ADDENDUM NO. 1

1.2.2019

EMBRACE PARK RESTROOMS

NORFOLK, NE

1 WALL SECTION
 NO SCALE

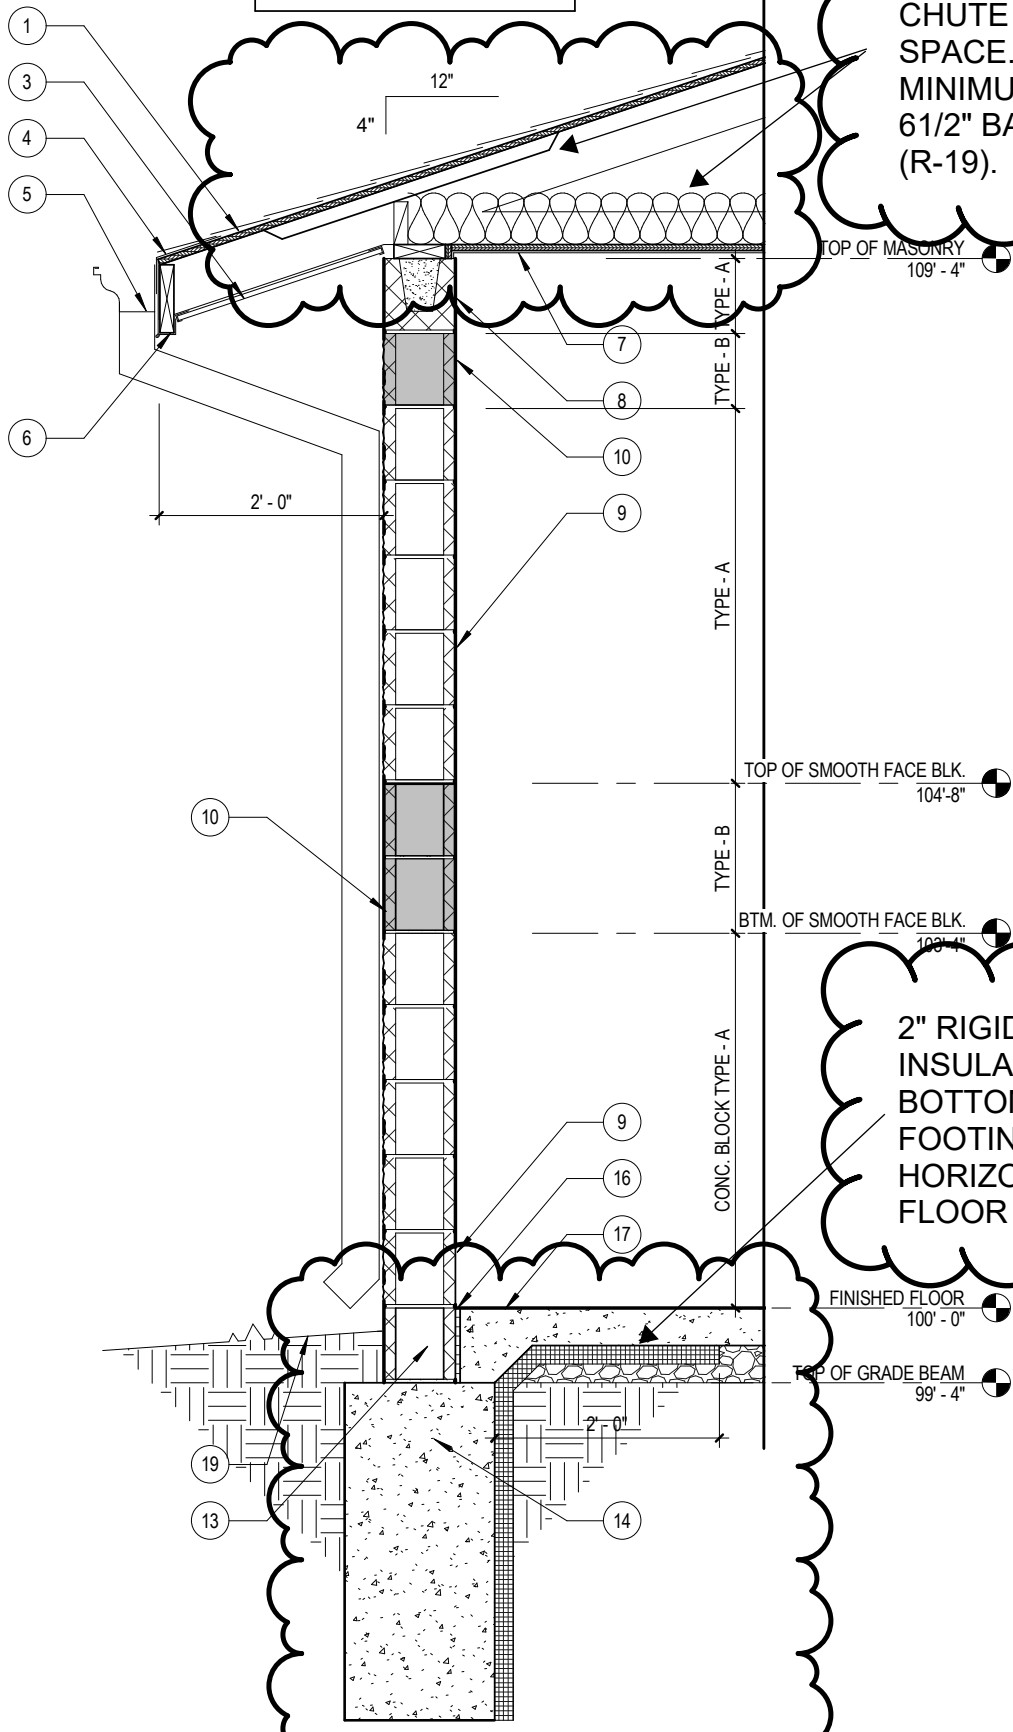
SHEET A4.01 – WALL SECTIONS

- A. SEE ENCLOSED DRAWING - WALL SECTION - 1.

NOTE:
 PROVIDE ICE AND WATER
 SHIELD - TYPICAL AT EAVES.

PROVIDE INSULATION
 CHUTE AT EACH TRUSS
 SPACE. CHUTE SHALL BE
 MINIMUM 2 1/2" DEEP WITH
 6 1/2" BATT INSULATION
 (R-19).

2" RIGID PERIMETER
 INSULATION - EXTEND TO
 BOTTOM OF TRENCH
 FOOTING AND 2'-0" MIN.
 HORIZONTALLY BELOW
 FLOOR SLAB.
